TOWN OF BAY HARBOR ISLANDS
DEVELOPMENT & REVIEW COMMITTEE MEETING
RESCHEDULED, TUESDAY, NOVEMBER 15, 2022

1. Review and discussion of Site Plan Application by PPG BHT Owner, LLC to construct a 44-unit Multi-Family Development to be located at 10143 East Bay Harbor Drive. Enclosed are the Site Plans and the Staff Report prepared by Town Planner Michael Miller.
2. Review and discussion of Site Plan Application by CHBH 103rd Street, LLC, to construct a 77-unit Multi-Family Development to be located at 10200-10290 East Bay Harbor Drive. Enclosed are the Site Plans and the Staff Report prepared by Town Planner Michael Miller.
3. Review and discussion of Site Plan Application by DDG 1055 BHI, LLC, to construct a 9-unit Multi-Family Development to be located at 1055 93 Street. Enclosed are the Site Plans and the Staff Report prepared by Town Planner Michael Miller.

**TOWN OF BAY HARBOR ISLANDS
COMMUNITY DEVELOPMENT
MEMORANDUM**

Subject: Site Development Plan Application – DRC Review #3
Proposed New Multiple-Family Development (44 DU)
Existing Bay Harbor Tower Site (30 DU)
10141-10143 East Bay Harbor Drive
Bay Harbor Islands Acct. No. SPR22-000024
MMPA Acct. No. 01-0702-1142

A-12

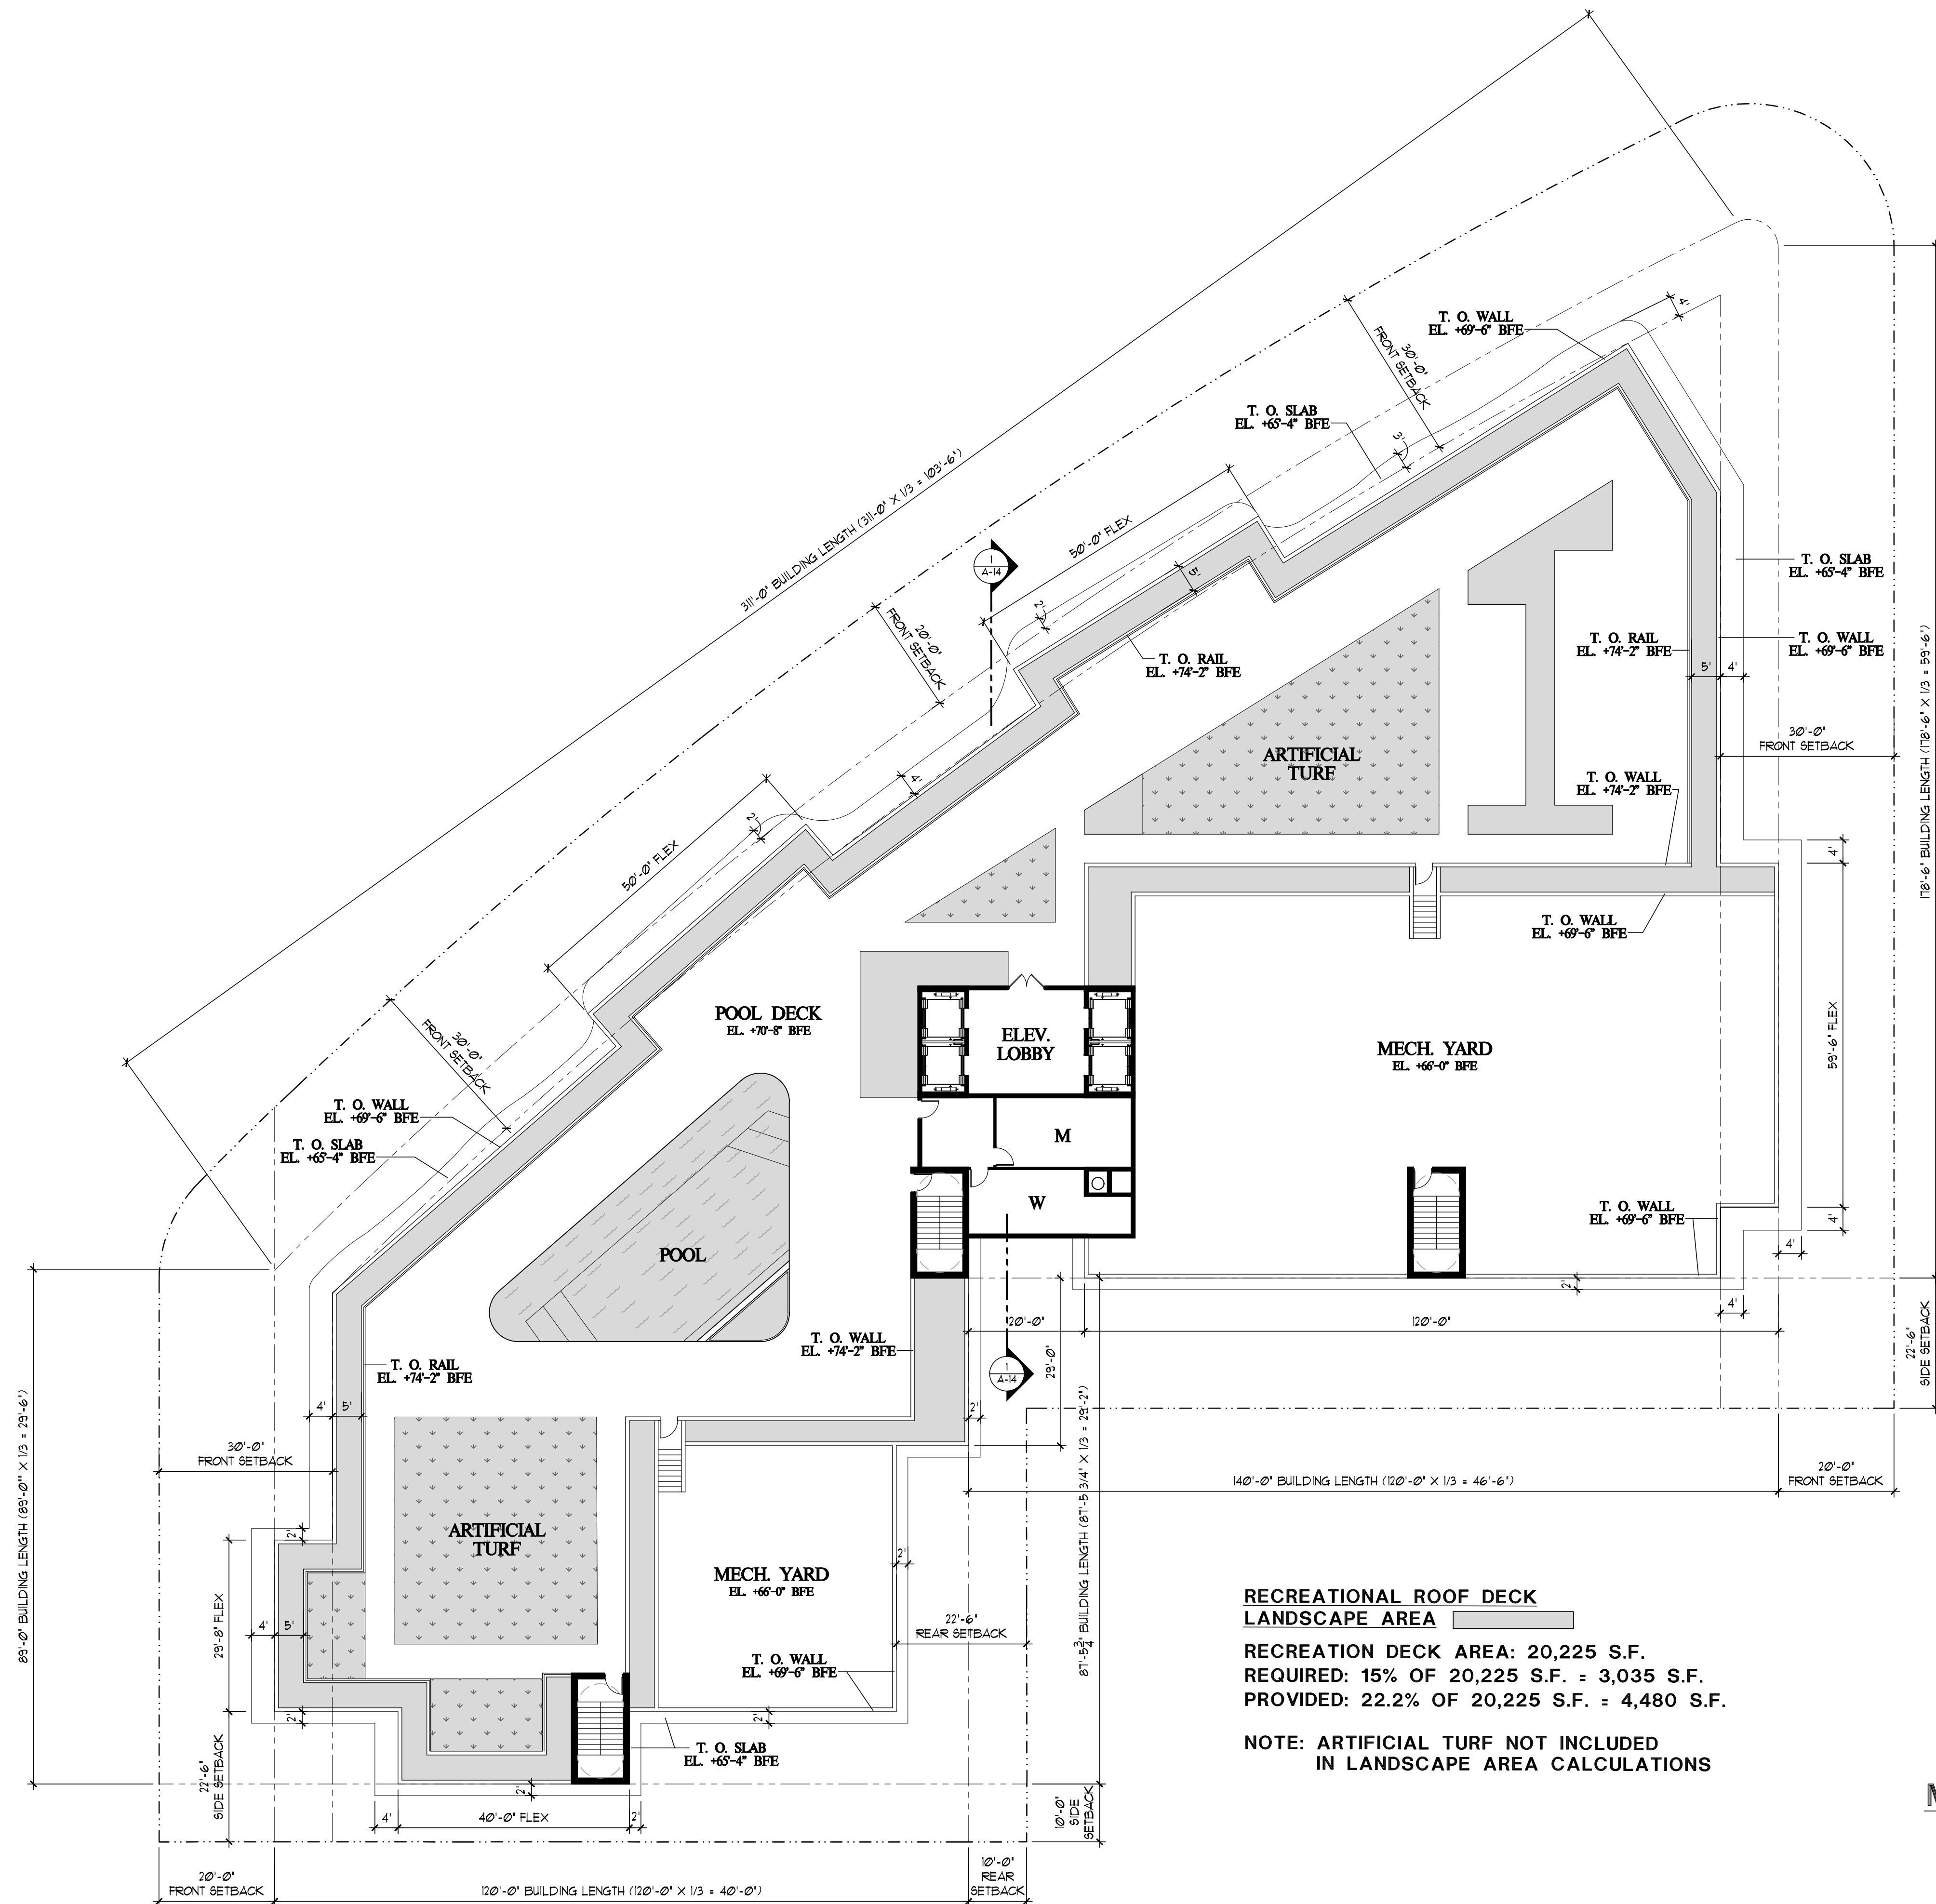
15. On Architectural Roof Plan Sheet A-12 and Landscape Plan Sheet LP-102 landscaping is noted on the roof. Please note that Sec. 23-11(62)(12) requires that if a portion of a rooftop is used for recreational purposes at least 15% of that area (not total roof area) must be landscaped (live landscaping). Artificial turf is allowed but does not count as part of the 15%. It is not clear if the artificial turf is being counted for the landscape area. Please clarify.

24. On Sheet A-12 there are no height dimensions noted for the numerous rooftop accessory structures. The maximum height allowed is 20' for elevator overrides / stairs and 10' for shade structures / canopies / trellis measured from the main roof deck. Parapet walls / etc. are limited to 5' in height above the main roof deck. Any raised decks for a pool / pool deck must be setback at least 5' from the edge of the main roof. See Sec. 23-12(25).

Response: Artificial turf is not included in the required landscape calculation. Sheet A-12 is updated to clarify. Sheet A-12 and LP-102 have been coordinated.

Response: Additional information has been added to Sheet A-12. In addition, Sheet A-12A has been added to show the heights of the elevator shafts, stair shafts, etc.
